## **Planning Commission Final Agenda**

**Monday, December 11, 2023**

**2. CCP-2023-0004: Concurrent Plat (3278 W. KESSLER MOUNTAIN/MOLLOY & AUST, 296):**

DD - LEVEL 00

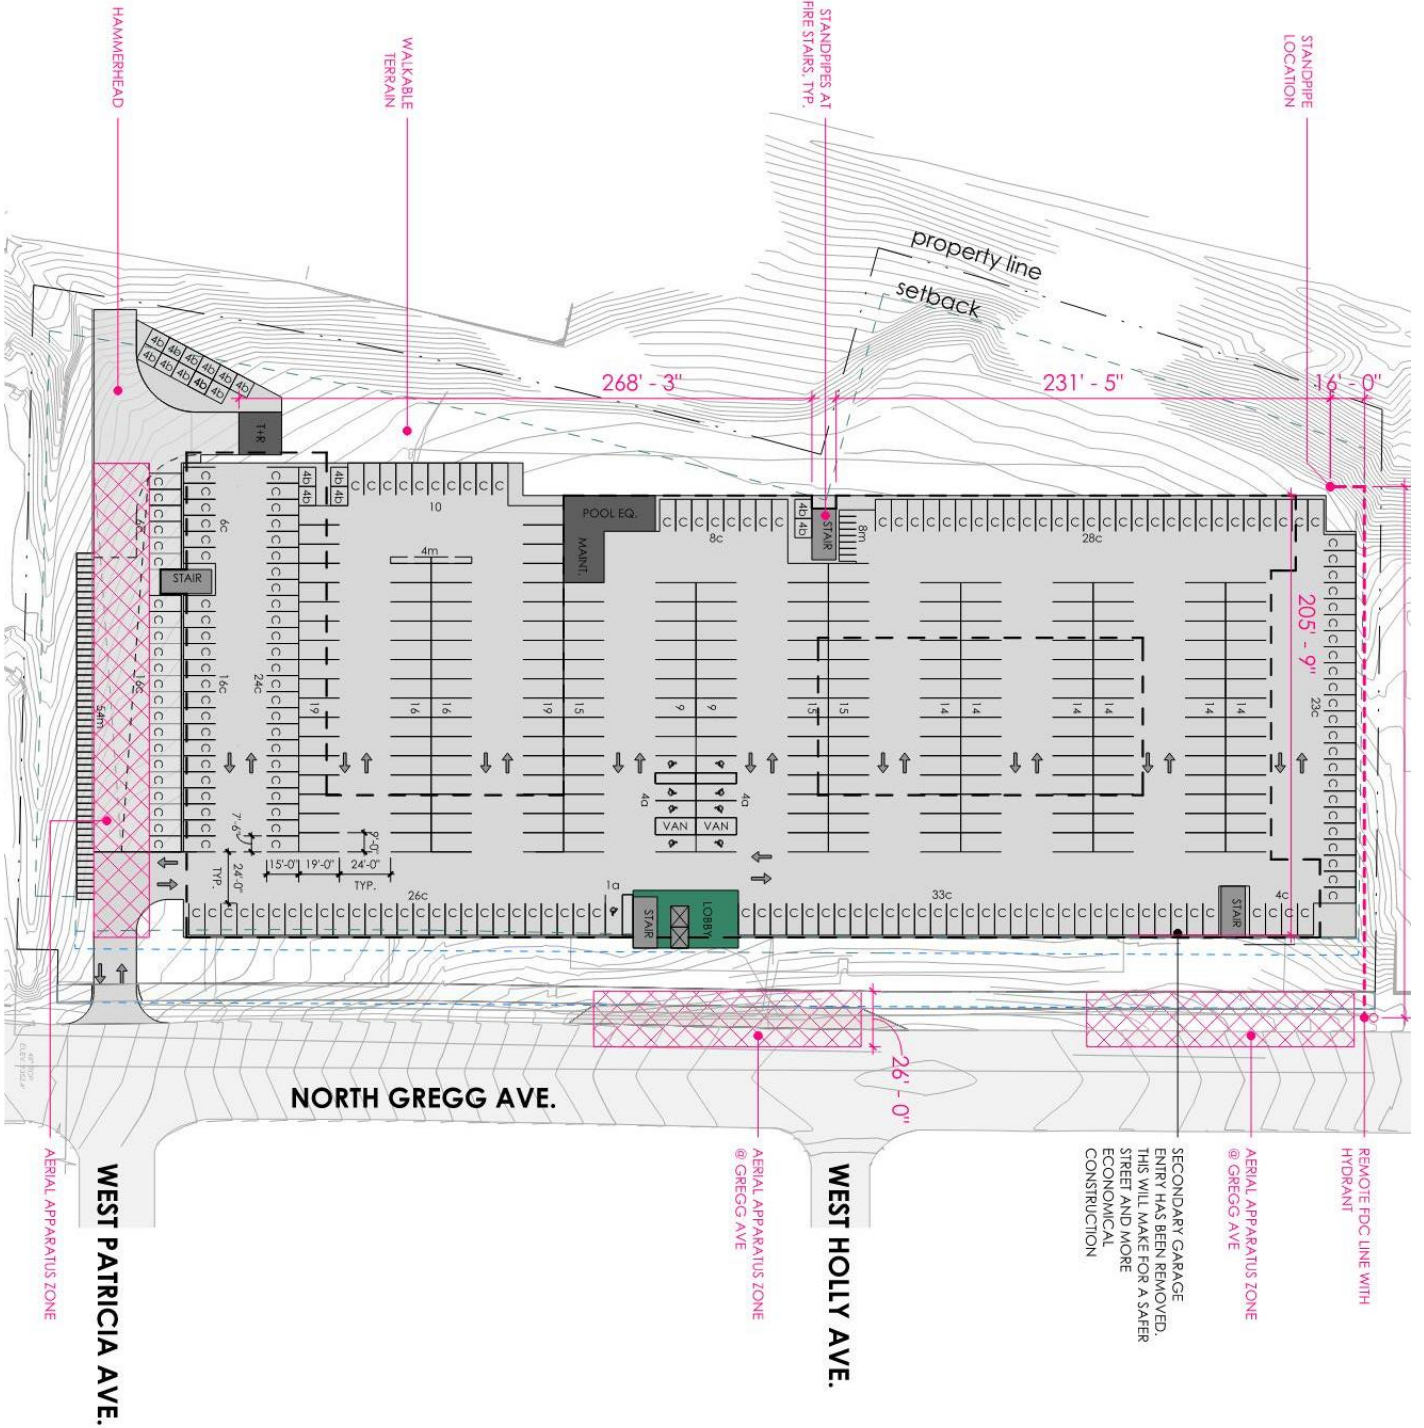
This item was tabled at the November 27, 2023 Planning Commission meeting at the applicant's request. In the interim, the variance request for §166.23(C)(4)(a) requiring pedestrian connections to the public sidewalk from ground floor dwelling units has been withdrawn and the variance request for §172.04(D) requiring a maximum of 35% compact spaces was revised from 46.8% to 49%.

1. **Planning Commission determination of a variance to §172.04(D), which requires that a maximum of 35% of the total automobile spaces may be compact. Staff recommends denial of the request for the reasons stated above.**
2. Approval of this variance request is only for the requests as stated above and does not extend approval to any variances not yet reviewed for at this stage or to overall development plans.

## STAFF EXHIBIT: AREAS OF CONCERN

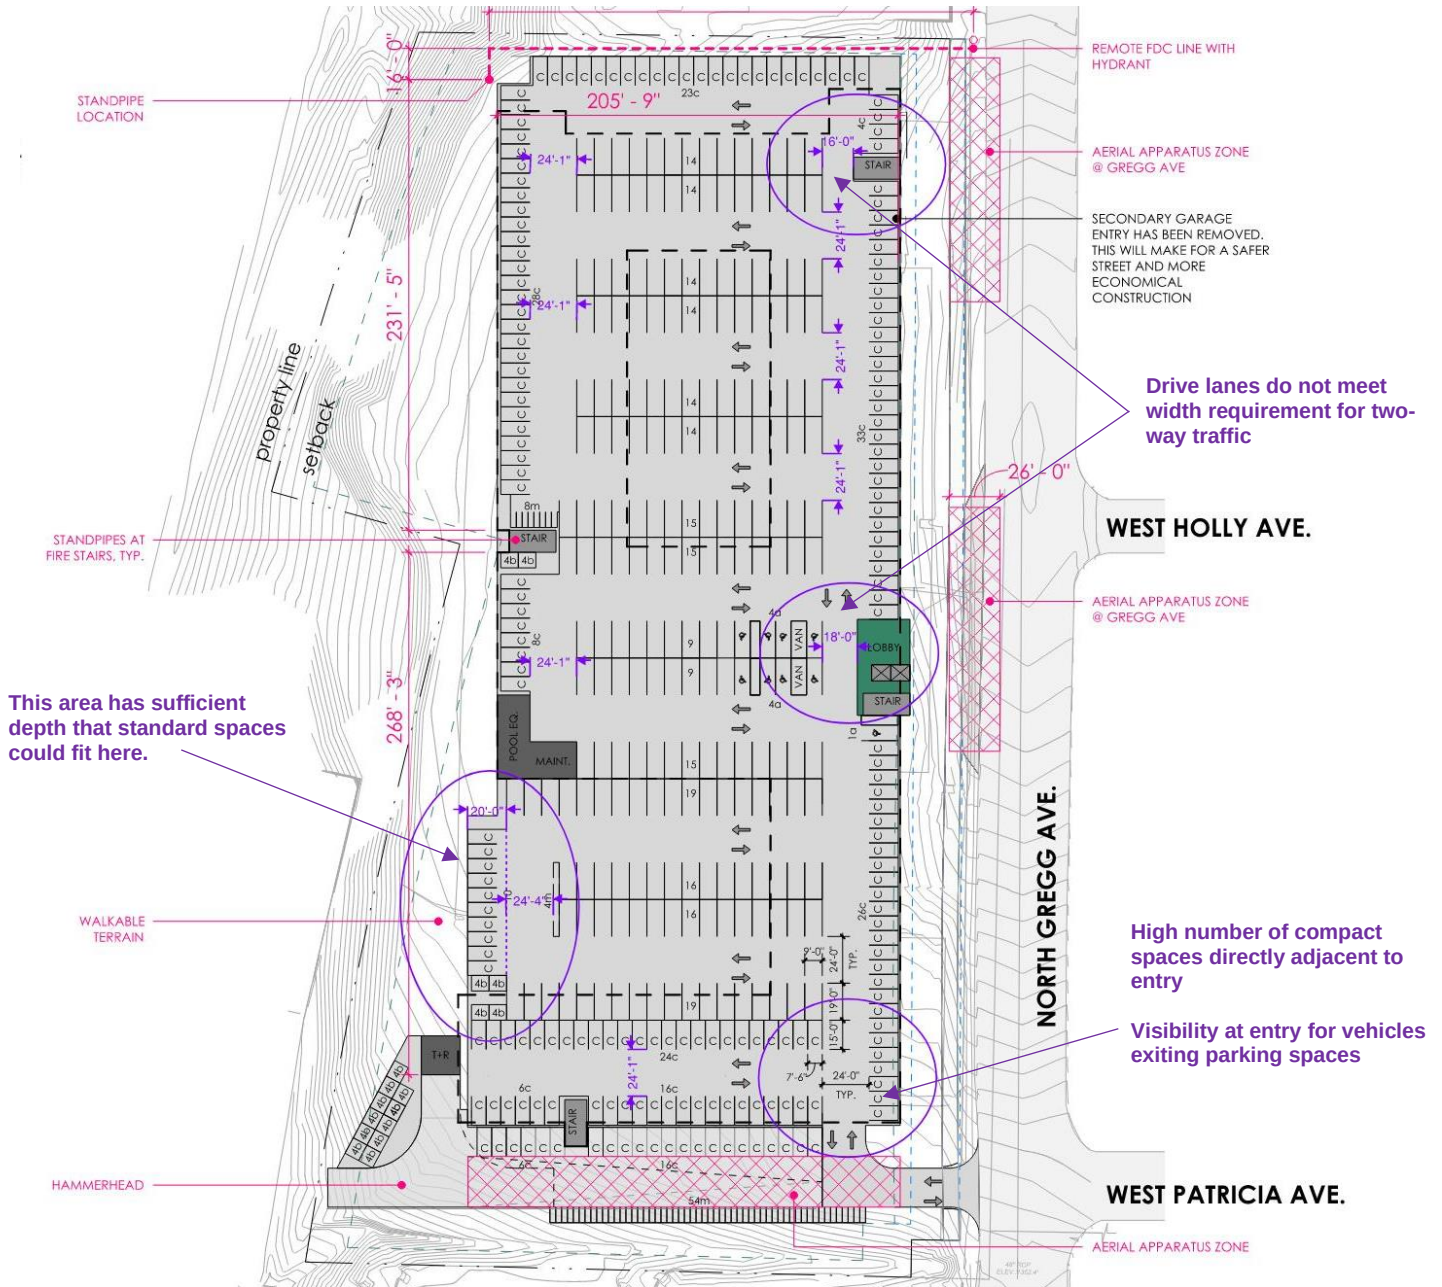
Additionally, staff has multiple comments relating to the overall design of the parking garage. First, the drive lanes narrow to approximately 16 feet and 18 feet in two locations adjacent to stairs on the eastern side of the parking deck, which does not provide sufficient space for two-way traffic. Second, a line of ten spaces designated as compact in the southwest corner appear to have sufficient depth that they could be utilized as standard spaces. Third, the plans appear to be three spaces short of the indicated 65 motorcycle spaces; however there does appear to be additional clear space to provide these spaces to the east or west of the long block of motorcycle spaces south of the parking garage. Finally, staff has concerns regarding visibility for users of the parking spaces directly abutting the garage entry to the east. Given concerns related to potential for unsafe driving conditions and outstanding functionality questions, staff recommends denial of the proposed variance.

**RECOMMENDATION:** Staff recommends Planning Commission deny VAR-2023-0050. If approved, staff recommends the following conditions.
